Access Compliance Report

Public Rights-of-Way

(Curb Ramps)

Intersection ID: 27620	Main Street: CAMFIELD_ST	Cross Street: ELM_LN	Location: NW
ADA ID: 54A0F3104BF4	Ramp Type: PerpDiag	Initial Pass/Fail: Fail	Overall Compliance: No
		Severity Score: 22.5

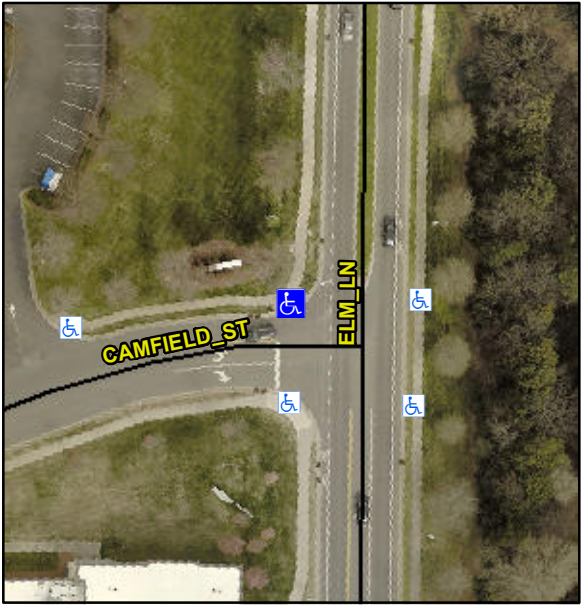
Codes/Mitigation Info/Possible Solution			Field Measurements/Component Compliance		
	Possible Solutions:		Compliance	Description	Data
	Remove & Replace Curb Ramp With Two New Directional Ramps or Equivalent.		No	Ramp Length (in)	47.0
			No	Ramp Width (in)	47.5
			N/A	Flare Type LT	N/A
			N/A	Flare Slope LT (%)	N/A
			N/A	Flare Traversable LT?	N/A
			N/A	Landing Length (in)	N/A
			N/A	Landing Width (in)	N/A
			N/A	Landing Slope (%)	N/A
			N/A	Landing X Slope (%)	N/A
			N/A	Landing Curb? (Y/N)	N/A
			N/A	Shared Landing?	N/A
			N/A	Gutter Ponding?	N/A
			N/A	Gutter Lip Ht (in)	N/A
			No	Painted X Walk1?	N/A
				X Walk 1 Direction	To S
			N/A	X Walk 1 Width (in)	N/A
				X Walk 1 Slope (%)	1.3
				X Walk 1 X Slope (%)	0.6
			N/A	Ramp inside XWalk1?	N/A
<p>Surveyor Notes:</p> <p>N/A</p> <p>PROW/ADA:</p> <p>Not Found, R304.5.1, R304.2.2, R304.5.3</p>			N/A	Flare Type RT	N/A
			N/A	Flare Slope RT (%)	N/A
			N/A	Flare Traversable RT?	N/A
